from
**Southern
Water**

Our ref
PLAN-035241

Proposal: Erection of 75 No. dwellings with associated parking, public open space & the creation of a new vehicular access. This application affects the character & appearance of the Main Road/Church Road Conservation Area & affects the setting of listed buildings.

Site: Y/98/20/PL: - Bonhams Field, Main Road, Yapton, BN18 0DX.

Southern Water MapGuide Browser

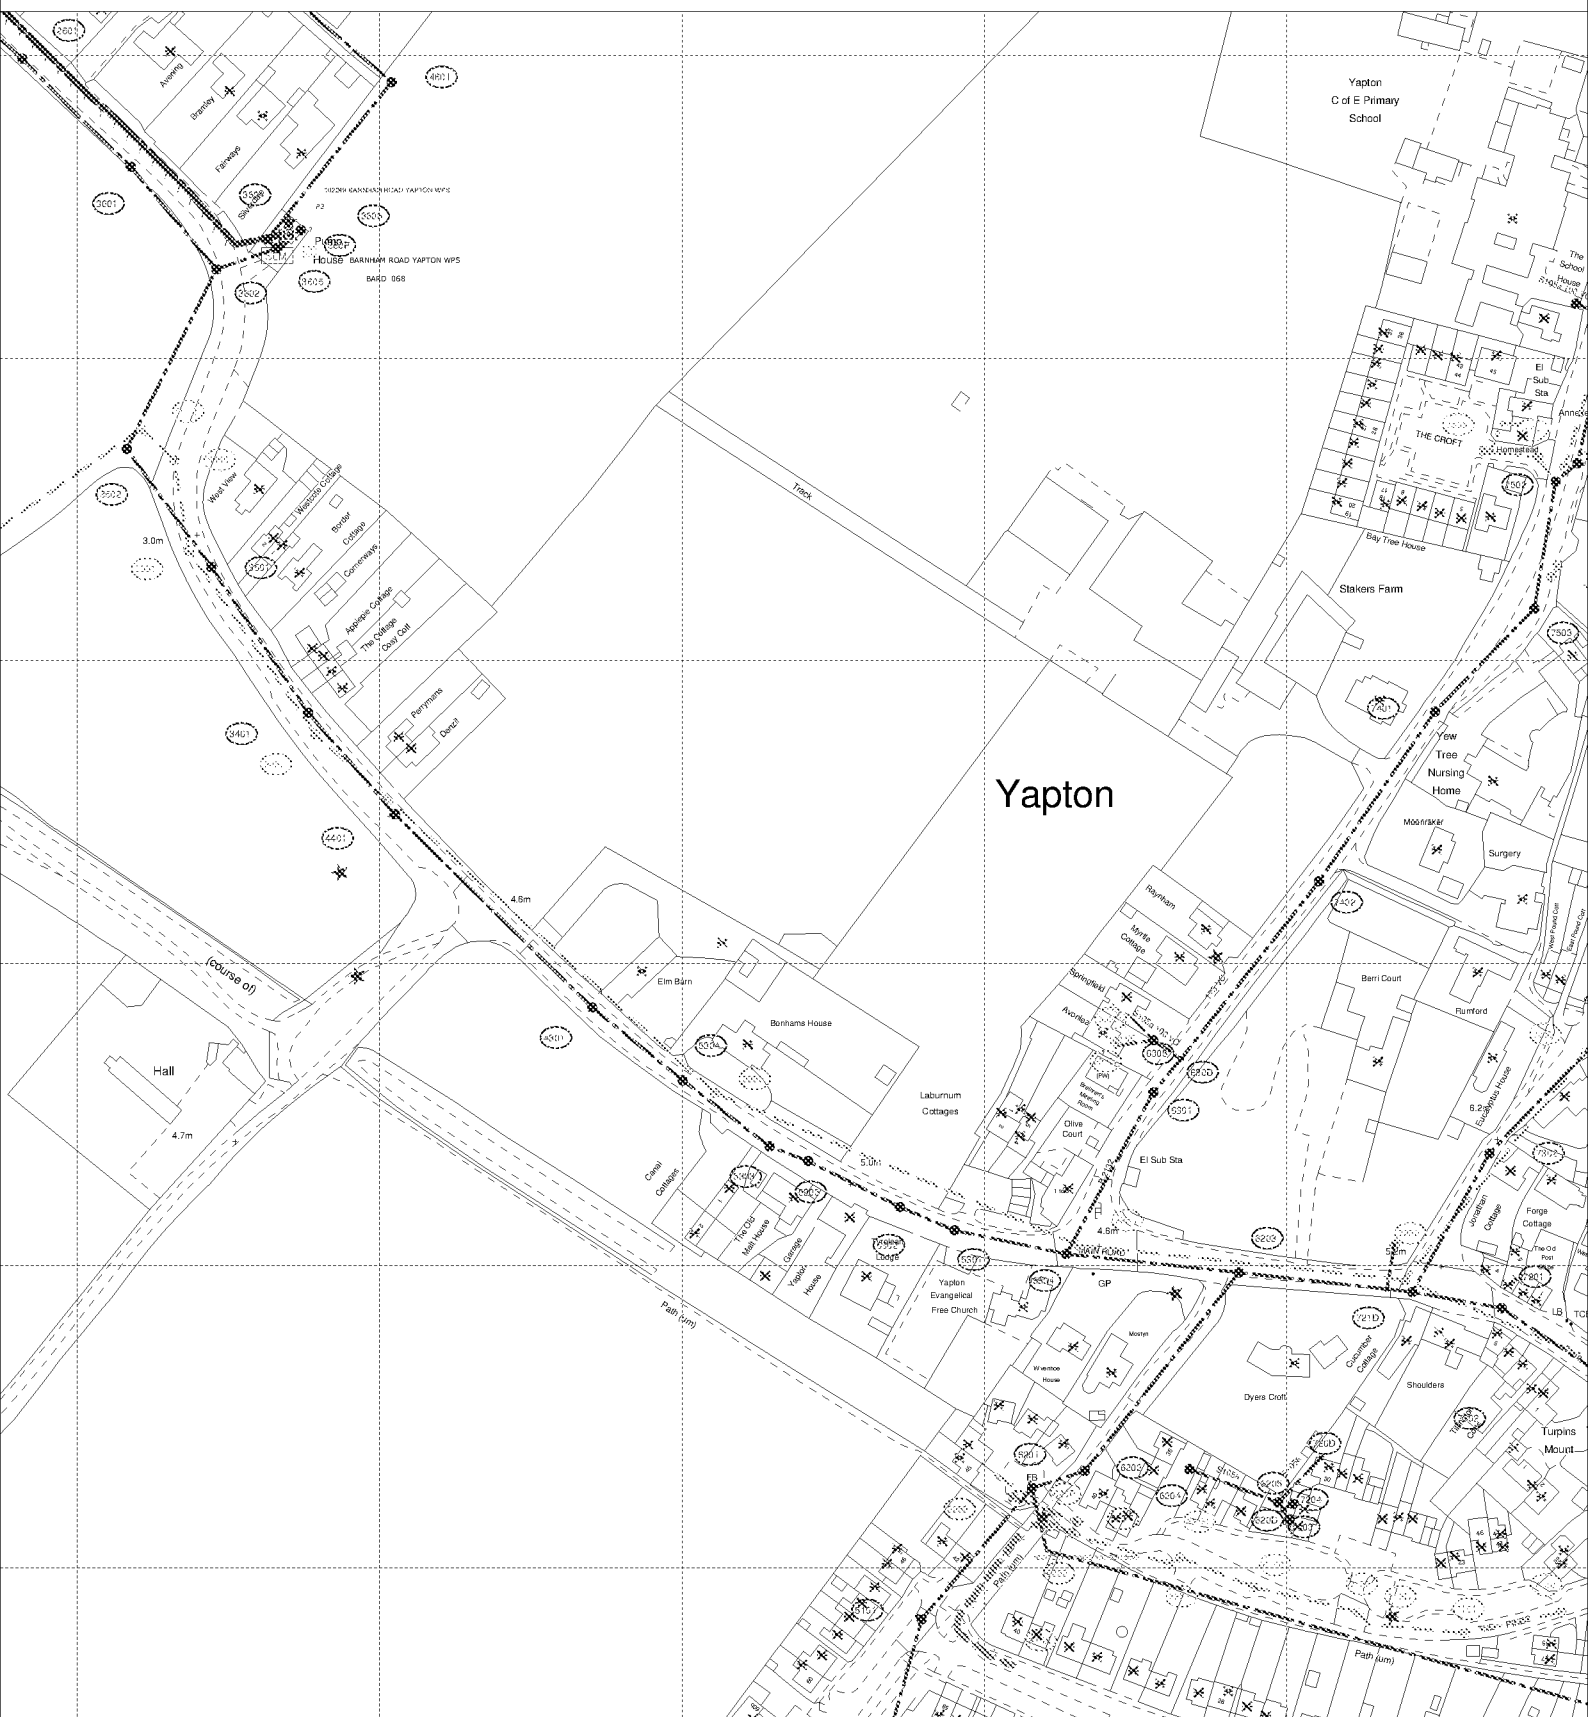
Please note there is a private surface water sewer within the development site.

It is possible that a sewer now deemed to be public could be crossing the development site. Therefore, should any sewer be found during construction works, an investigation of the sewer will be required to ascertain its ownership before any further works commence on site.
